Site Address :
 NEW BREAKS FARM,
 SWINFLEET,
 NR. GOOLET,
 DN14 8DZ.

Project:
 PROPOSED BARN CONVERSION.

Drawing Title:
 PLANNING STATUS : SCHEME "B"
 PROPOSED GENERAL ARRANGEMENT OF
 SITE / FLOOR PLANS & ELEVATIONS.

Drawing Number: Rev:
H.CON.04.22.03 **B**

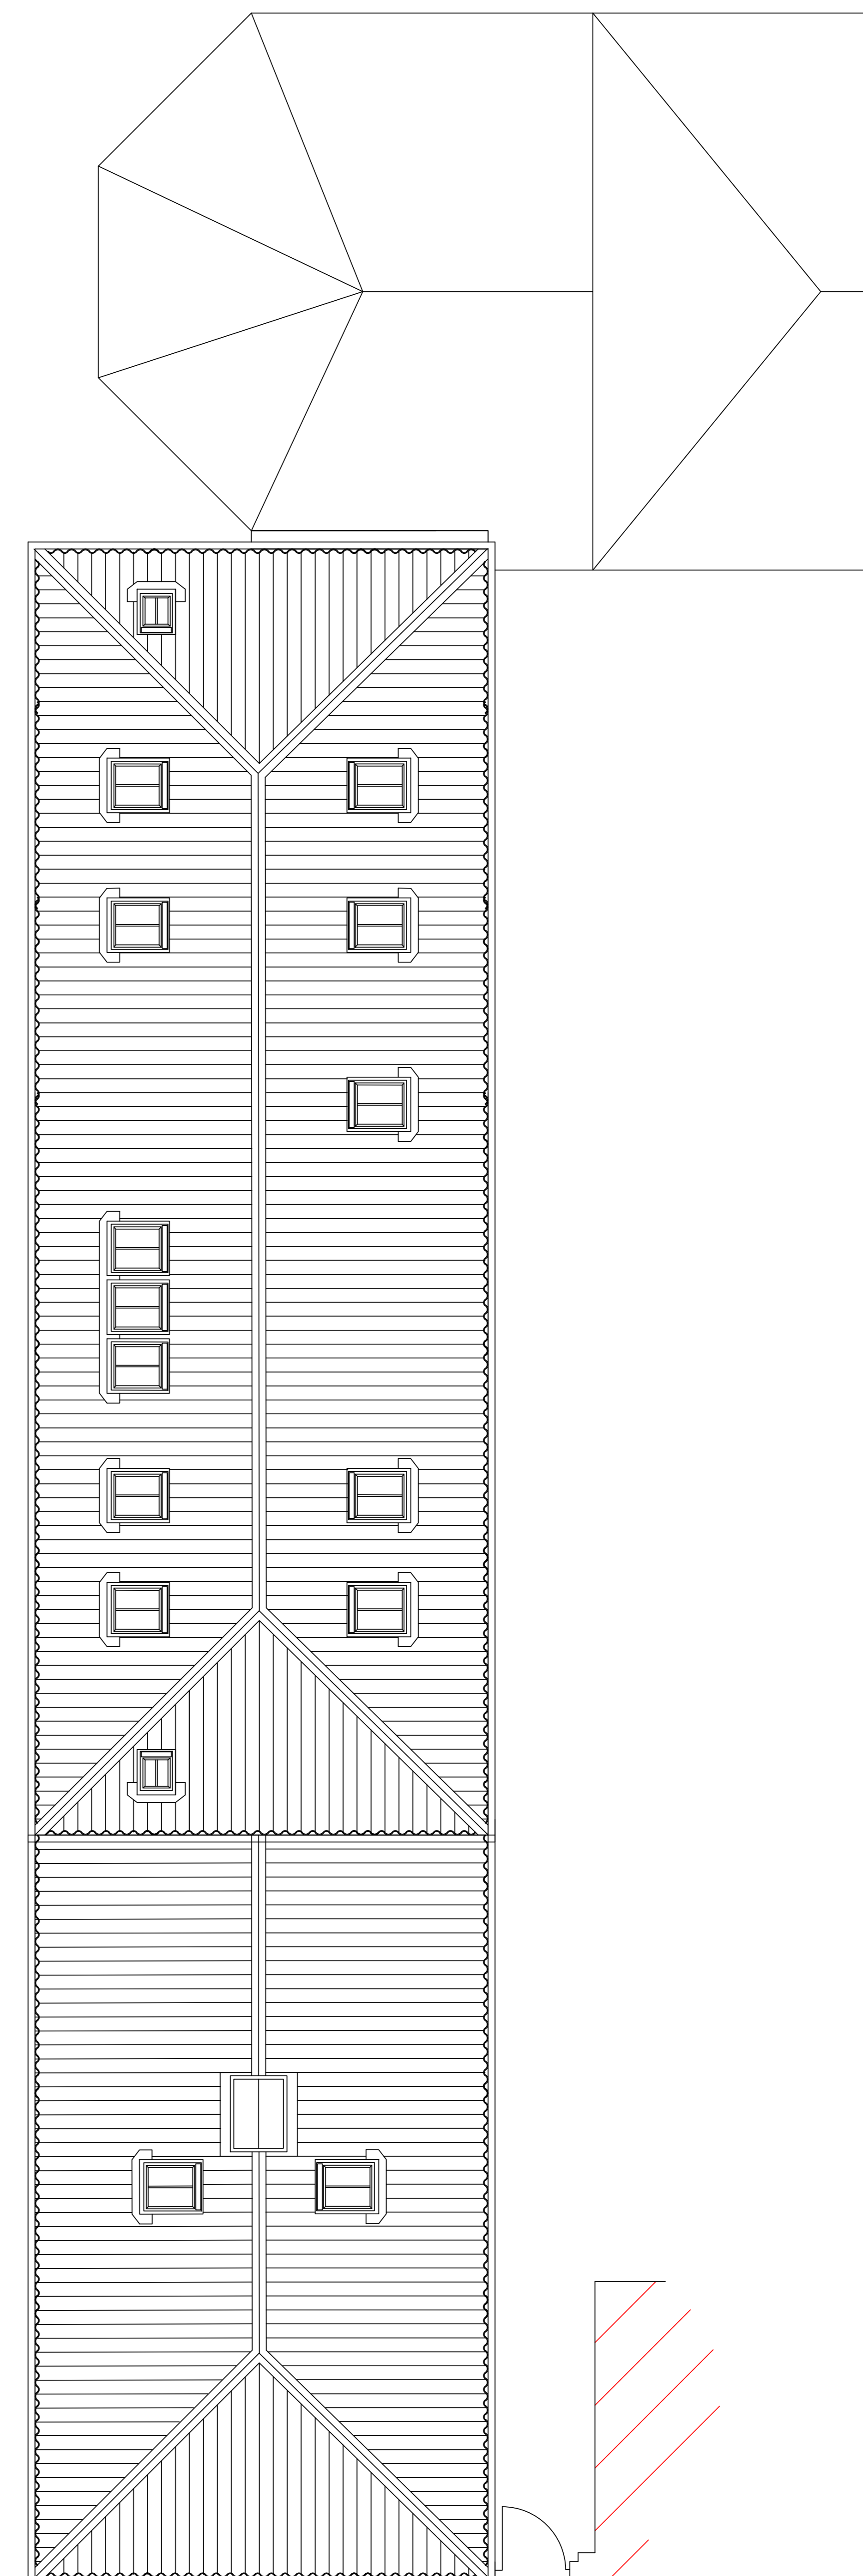
REVISION 'B' (OCTOBER 2023)
 Drawing revised to illustrate amendments as recommended by conservation officers to include :-
 1. EAST ELEVATION :
 3 Windows above main entrance reduced to 2 with a sensitive break between both.
 Number of Conservation "Heritage" style Velux rooflights above main entrance reduced from 3 to 1 and Velux rooflights generally reduced in size to be proportional with slope of roof.
 2. WEST ELEVATION :
 Conservation "Heritage" style Velux rooflights reduced in size to be proportional with slope of roof.
